Access Compliance Report

Public Rights-of-Way

(Curb Ramps)

Intersection ID: 16349	Main Street: FARM_POND_LN	Cross Street: MEADOWDALE_LN	Location: SE
ADA ID: 4F51A72C527F	Ramp Type: PerpDiag	Initial Pass/Fail: Fail	Overall Compliance: No
Severity Score: 37.5			
Codes/Mitigation Info/Possible Solution		Field Measurements/Component Compliance

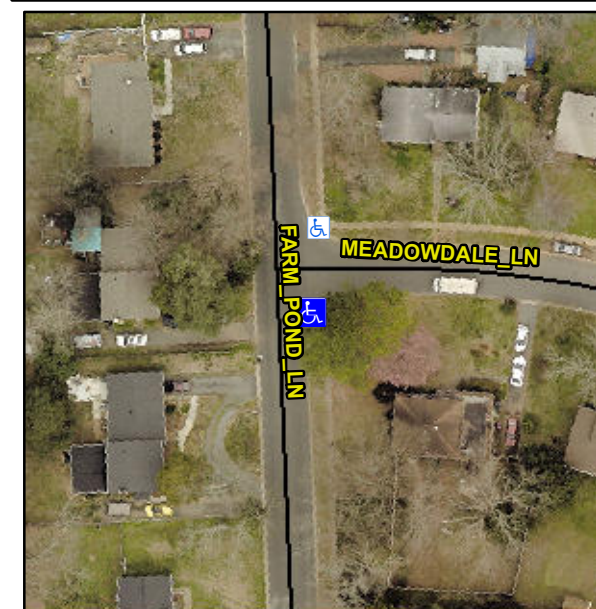
Not Found, R304.2.2, R304.5.3

Compliance	Description	Data	Compliance	Description	Data
N/A	Ramp Length (in)	39.0	No	Ramp Slope (%)	9.0
Yes	Ramp Width (in)	48.0	No	Ramp XSlope (%)	12.4
N/A	Flare Type LT	N/A	N/A	Flare Type RT	N/A
N/A	Flare Slope LT (%)	N/A	N/A	Flare Slope RT (%)	N/A
N/A	Flare Traversable LT?	N/A	N/A	Flare Traversable RT?	N/A
N/A	Landing Length (in)	N/A	N/A	DWS Provided?	N/A
N/A	Landing Width (in)	N/A	N/A	DWS Contrast?	N/A
N/A	Landing Slope (%)	N/A	N/A	DWS Length (in)	N/A
N/A	Landing X Slope (%)	N/A	N/A	DWS Full Width?	N/A
N/A	Landing Curb? (Y/N)	N/A	N/A	DWS Offset (in)	N/A
N/A	Shared Landing?	N/A			
N/A	Gutter Ponding?	N/A	N/A	Gutter Slope (%)	N/A
N/A	Gutter Lip Ht (in)	N/A	N/A	Gutter X Slope (%)	N/A
N/A	Painted X Walk1?	No	N/A	Painted X Walk2?	No
	X Walk 1 Direction	To SE		X Walk 2 Direction	To NW
N/A	X Walk 1 Width (in)	N/A	N/A	X Walk 2 Width (in)	N/A
	X Walk 1 Slope (%)	9.4		X Walk 2 Slope (%)	0.8
	X Walk 1 X Slope (%)	2.0		X Walk 2 X Slope (%)	10.0

Remove & Replace Curb Ramp With Two New Directional Ramps or Equivalent.
